Comment on FTS CGMSAP dated Sept 18, 2009

GRU

February 12, 2010

Figure 1. Locations of Surficial Aquifer wells proposed for sampling and redevelopment at the Cabot Carbon/Koppers Superfund Site.

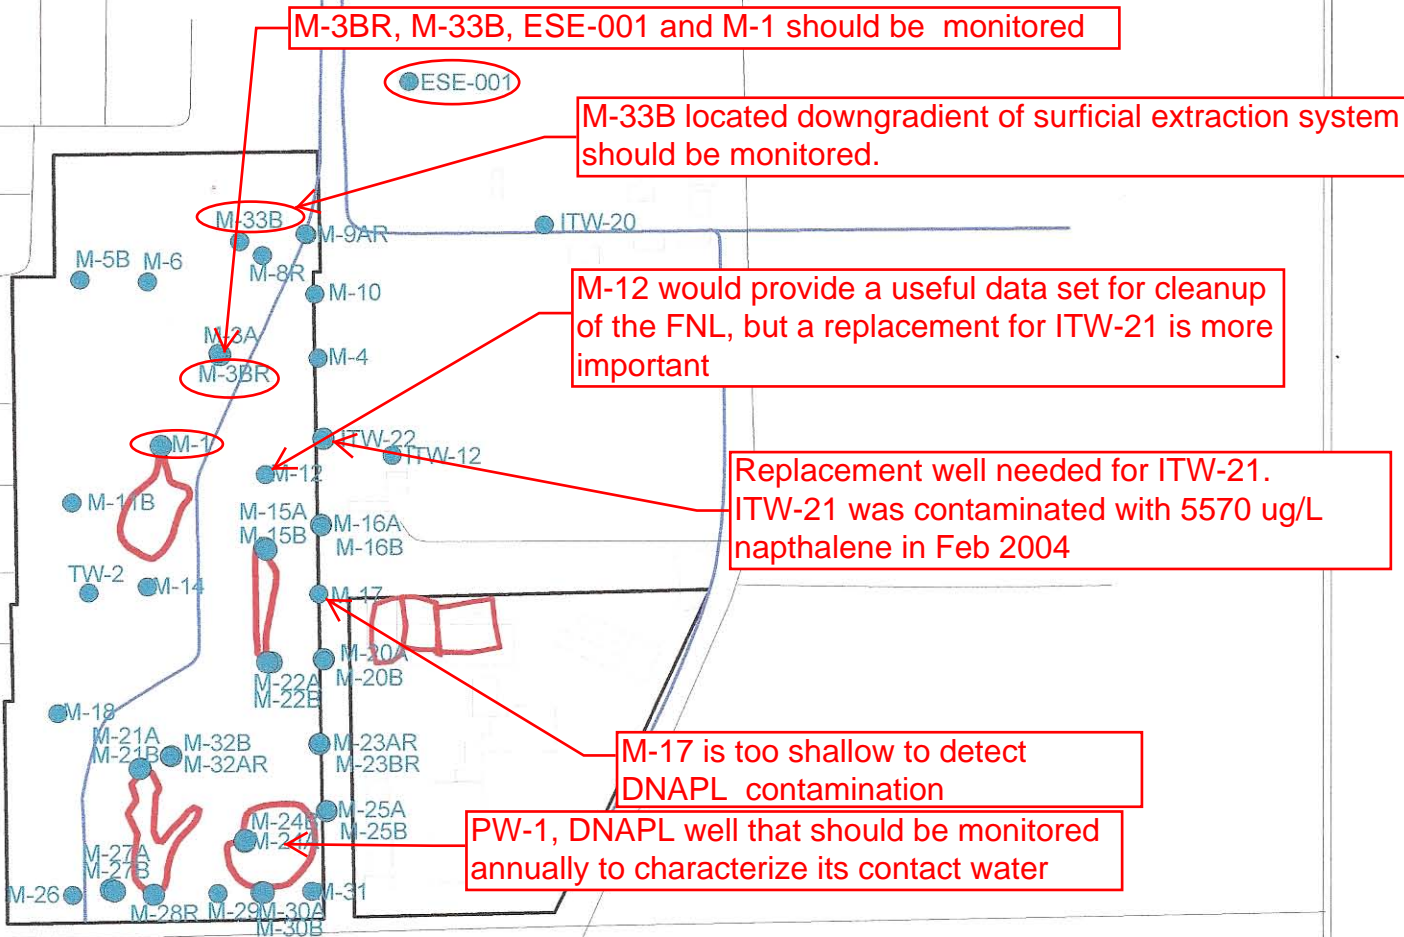
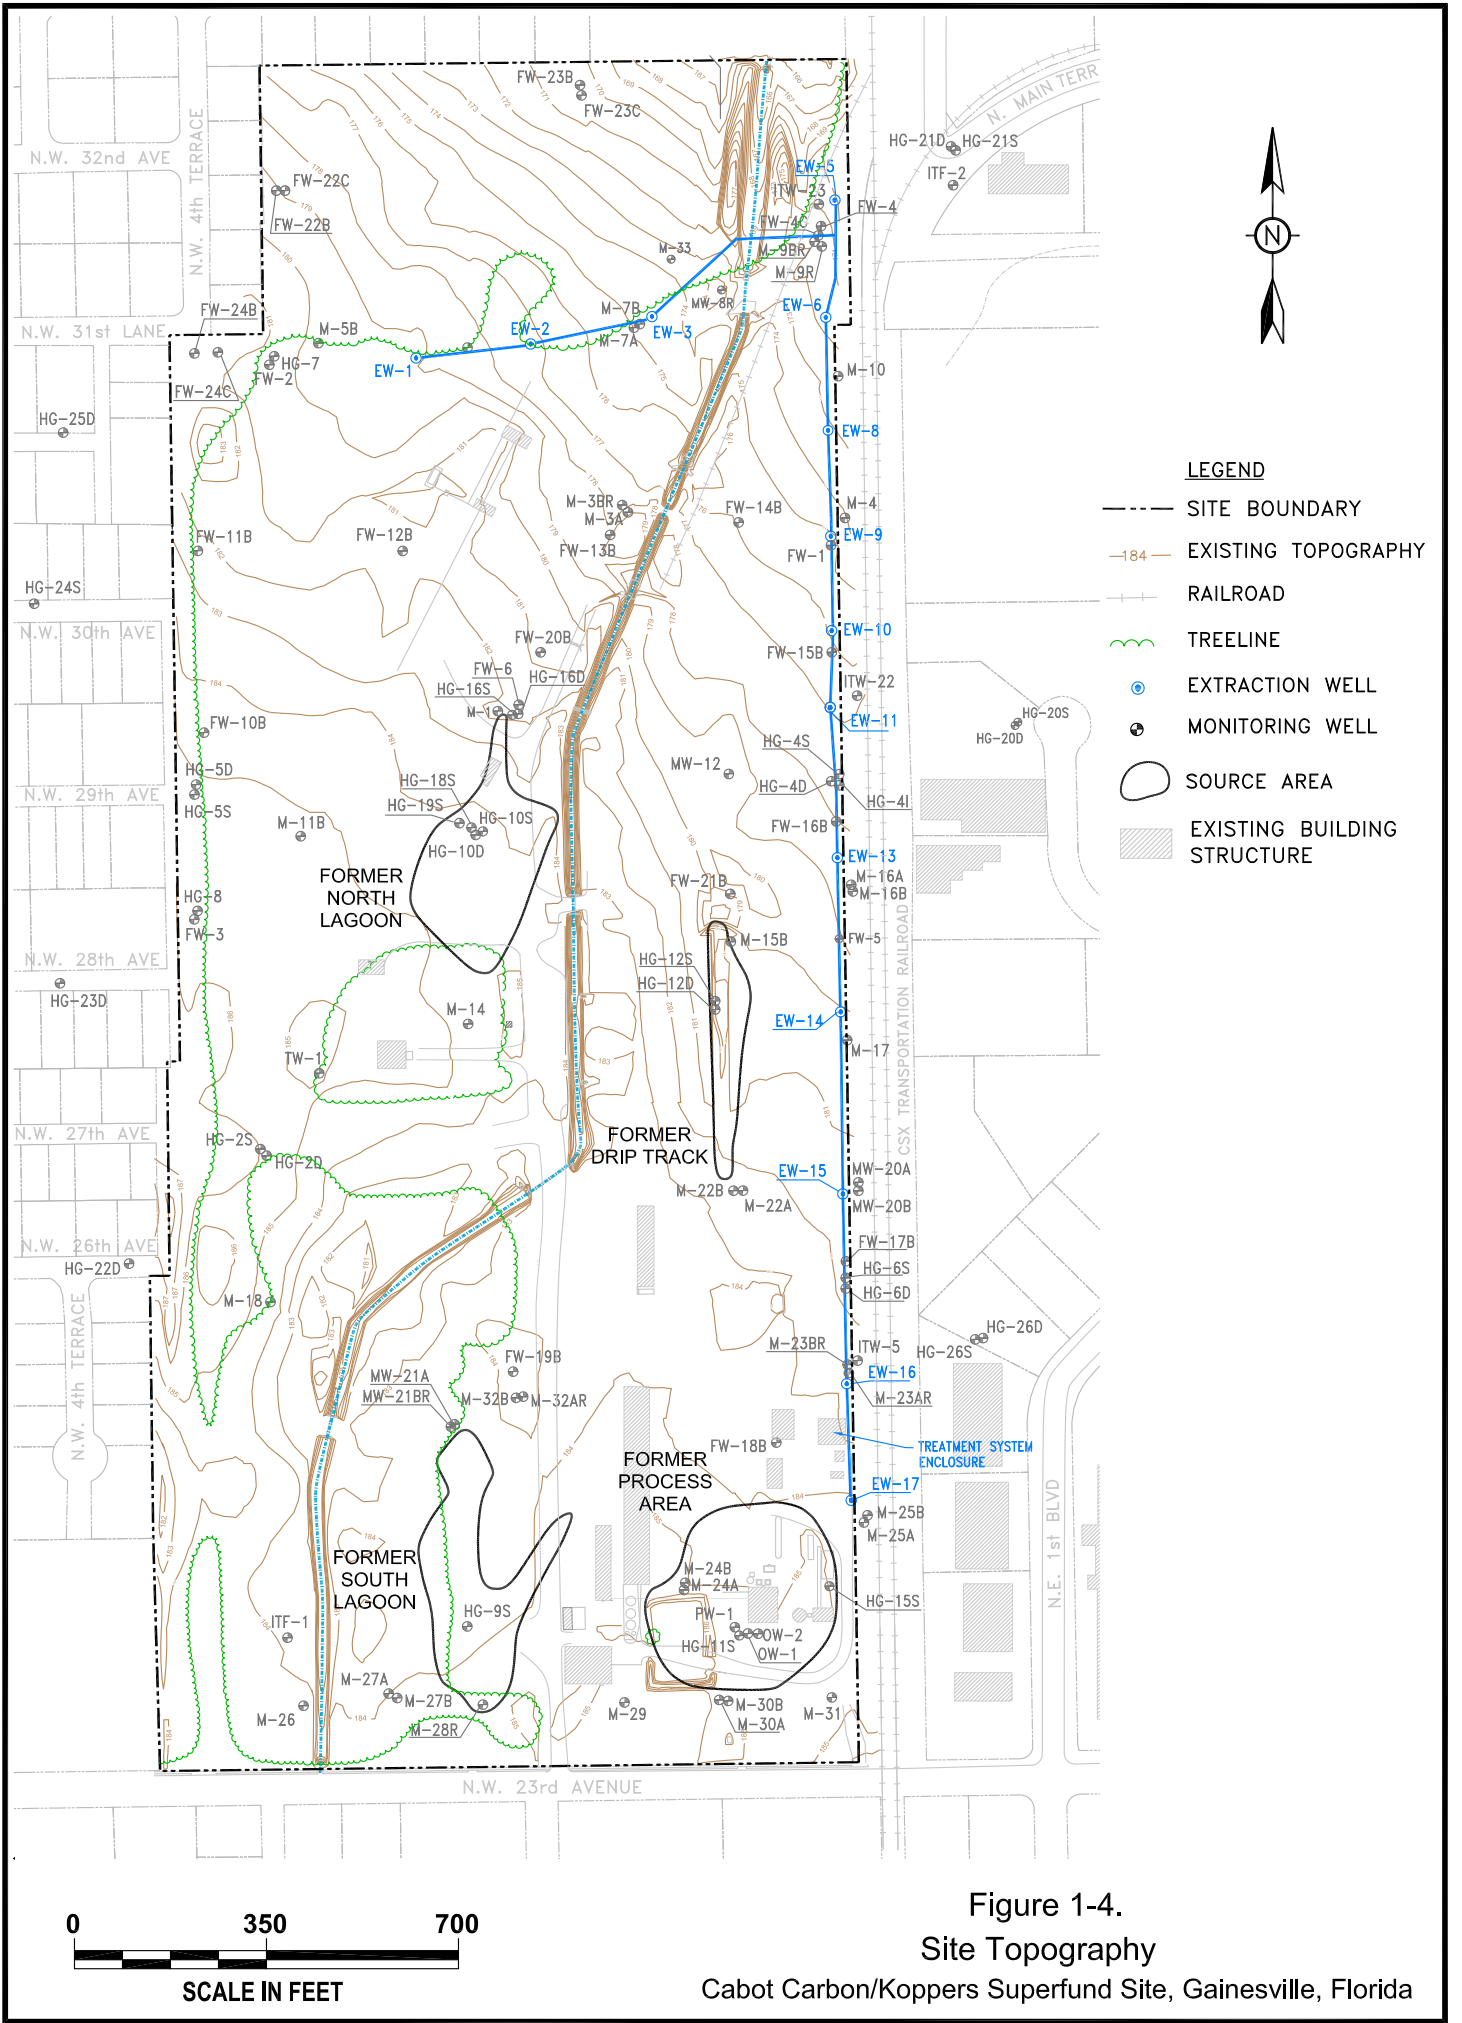
*GRU recommended in our comments dated December 3, 2008 that the CGMSAP include regular monitoring of five additional wells are M-1 [FNL], M-3BR [NE of FNL], M-12 [Former Drip Track], ESE-001 [off-site to the NE] and a replacement well for ITW-21 (ITW-21R), and PW-1. **Please see attached figure that shows the locations of those five MWs.** We see no reason to monitor ITW-12 and -22, once ITW-21R has been installed. The September 18, 2009 version of the CGMSAP does not include these wells. We believe that wells (ITW-12, ITW-21R), and M-33B should be added to the list. All surficial wells that are monitored should be sampled semiannually.*
